**From:** Jeff Senior <[REDACTED]>  
**Sent:** Thursday, 13 December 2018 4:19 PM  
**To:** Keith Ng  
**Cc:** Peter Lay  
**Subject:** HPE CM: F6 Submission from Canterbury Bankstown Council  
**Attachments:** Scan\_161614.pdf

The submission concerns the route of the electricity supply to the project.

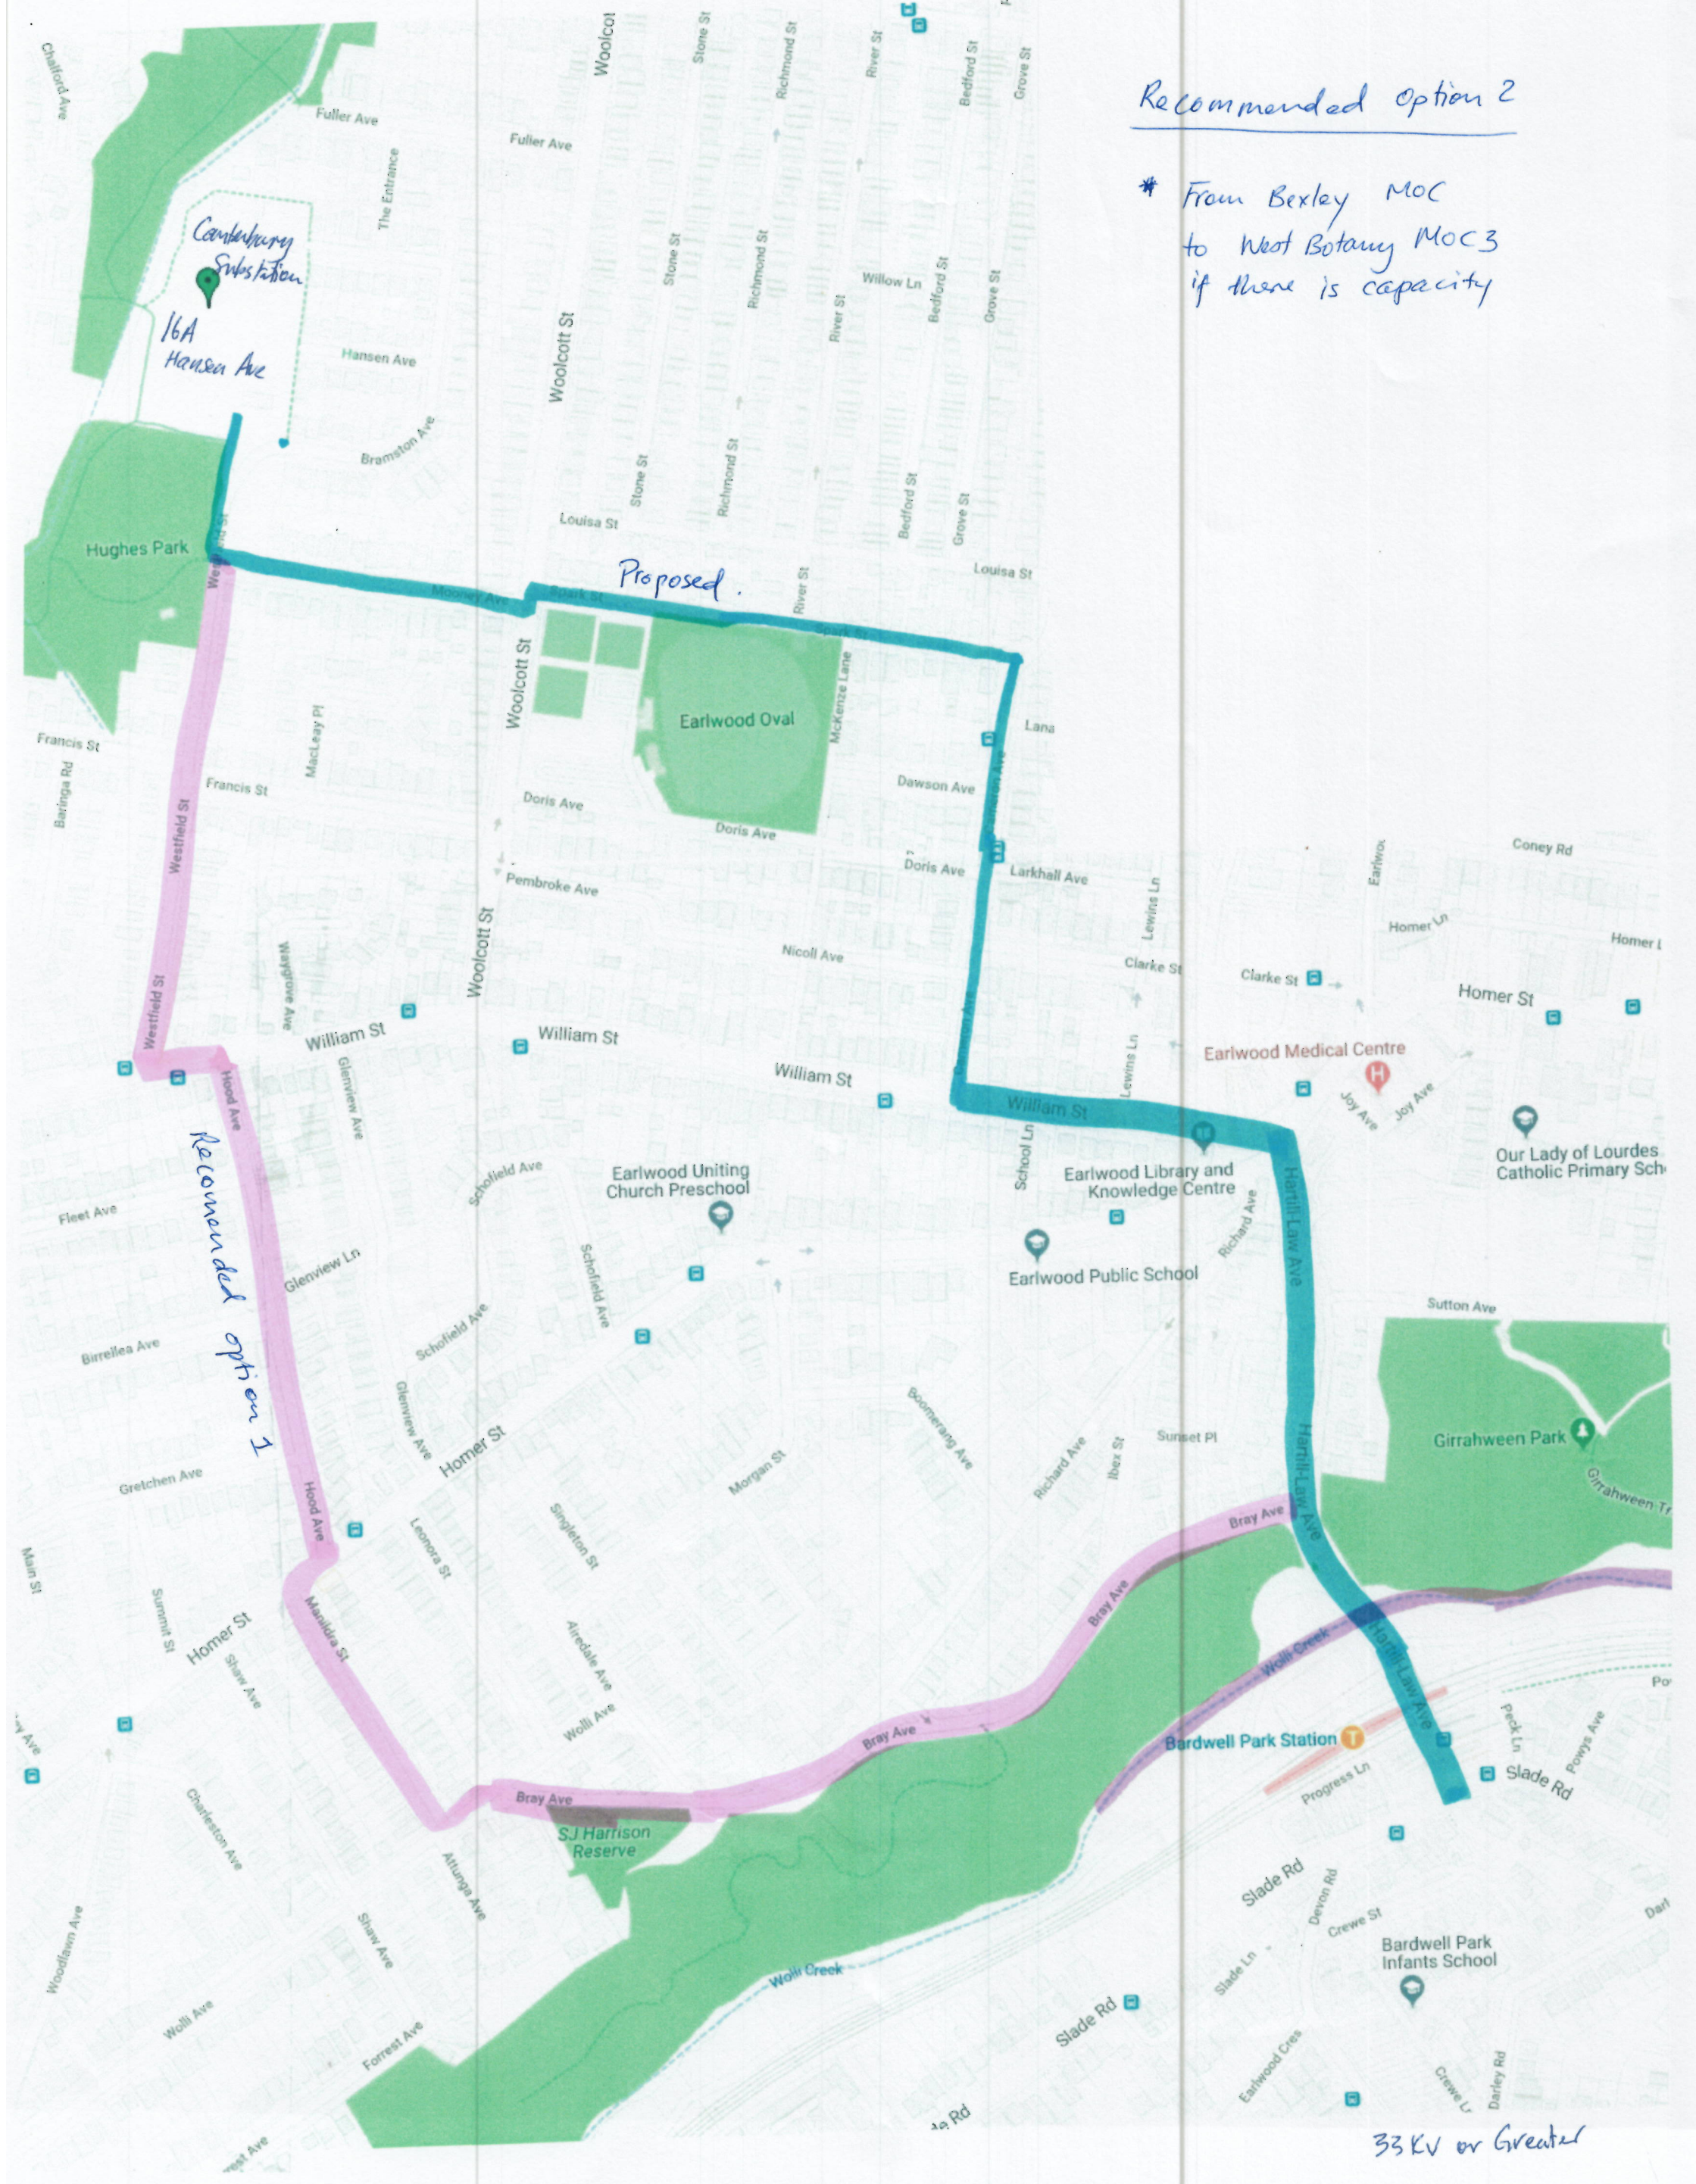
Council proposes 2 options to the proposed route.

Option 1. Via

Westfield, William, Hood, Homer, Matilda Bray on to Hartill Law to the Proposed route

Option 2 is to utilise the electrical feed to the Bexley MOC and head to West Botany MOC3, if there is capacity. This could be via Bexley Road

## Recommended option 2

\* From Bexley MOC  
to West Botany MOC3  
if there is capacity

33 kV or Greater
